BULLETIN NO. 0095

GHD/GH3 Keyboard unit

Change of supply specification of single GH keys

Actuate rubber : VAY41300

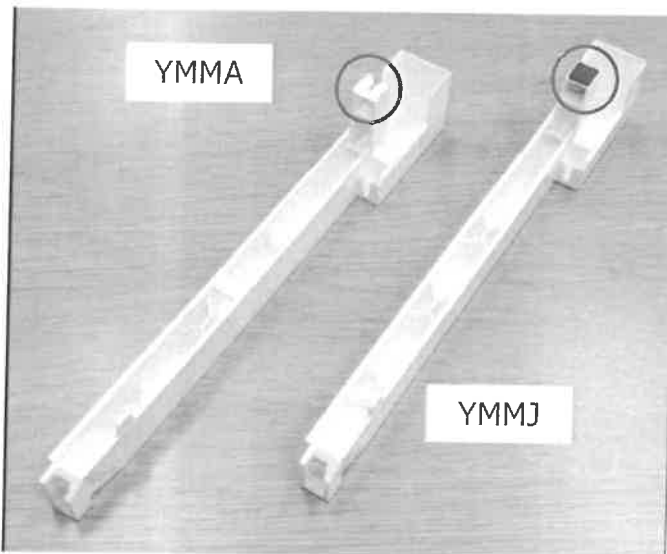
- Remove actuate rubber from old key and reuse it to new key.

- * Insert actuate rubber properly. Otherwise, the key rubber drops off and the following problems will occur.

- Key height gets lower than original position

- Mechanical noise

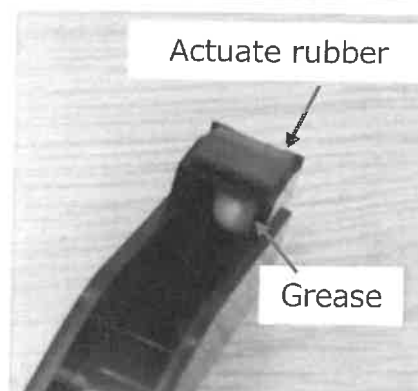
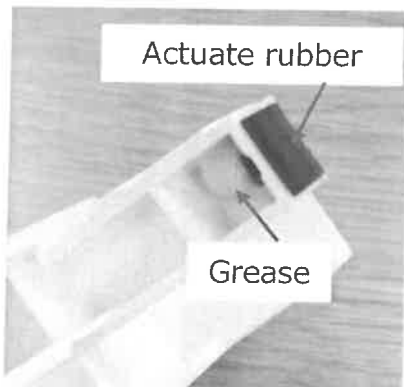
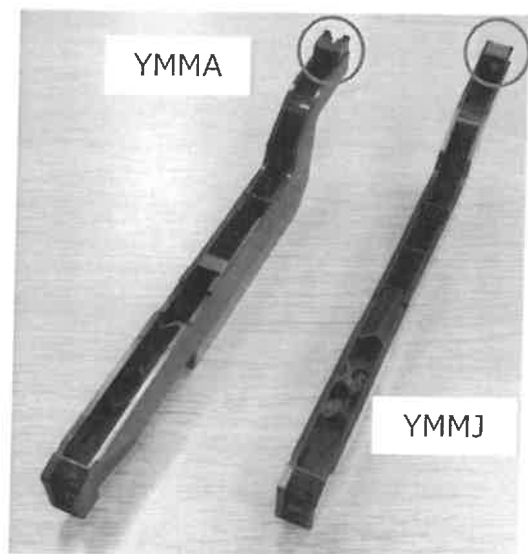
- * If the amount of grease on actuate rubber is less than that shown in the following picture, add grease.

Grease (G-1066Y) : AAX90710
